Subject: FCC Class II Permissive Change for AzureWave Technologies, Inc.
FCC ID: TLZ-CM389NF (Original Grant date: 07/09/2014)

This is to request a Class II permissive change for AzureWave Technologies, Inc., product description: IEEE 802.11 2x2 MIMO a/b/g/n/ac Wireless LAN + Bluetooth + NFC NGFF Module (FCC ID: TLZ-CM389NF), originally granted date on 07/09/2014. The module itself has not changed.

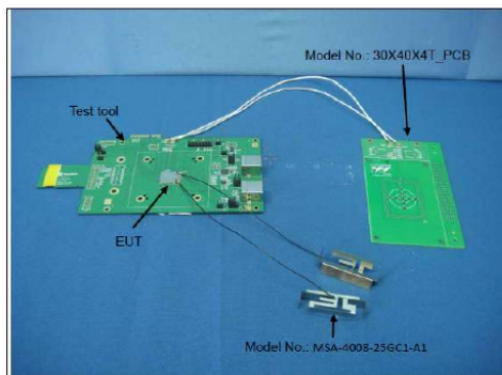
The above product is same as previously FCC granted product. However, it is installed in the host unit (Display module). It uses Cortec Part# SMASFR8-1200B-40X00I coaxial cable and Siretta Part# Tango 23 antenna. The old antenna type is PCB antenna. The new antenna type is dipole puck antenna. However, the gain of the new antenna does not go beyond the requirements established in the applicable RSS regulations in the original certification.
